AUTOMATIC TRANSMISSION

OVERDRIVE SWITCH

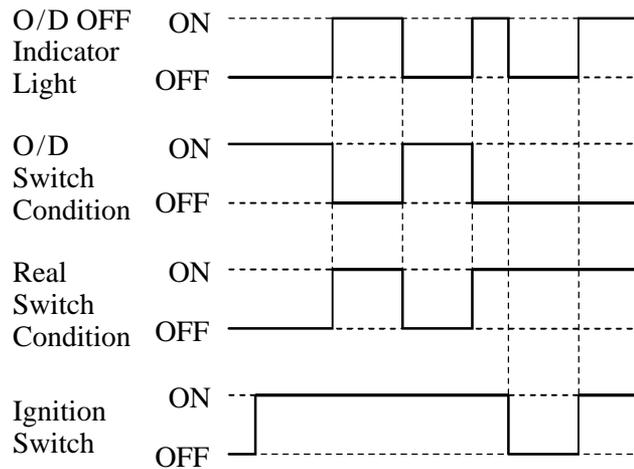
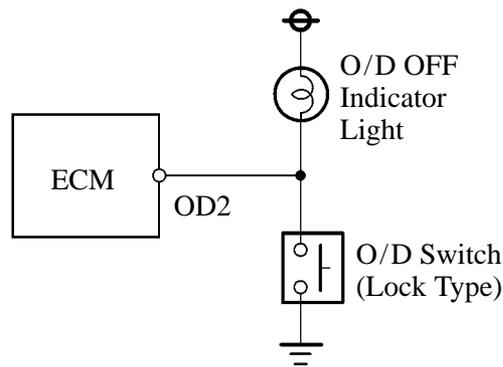
The overdrive switch has been changed from the previous ON/OFF lock type to the momentary type switch. Pressing the momentary switch closes (turns ON) the contact points, and releasing the switch opens (turns OFF) the contact points. Accordingly, pressing the switch causes the signal to be input into the ECM. Pressing the switch in overdrive turns OFF the overdrive. Pressing it again turns the overdrive back ON. When the overdrive is OFF, turning the ignition switch from OFF to ON turns the overdrive back ON.
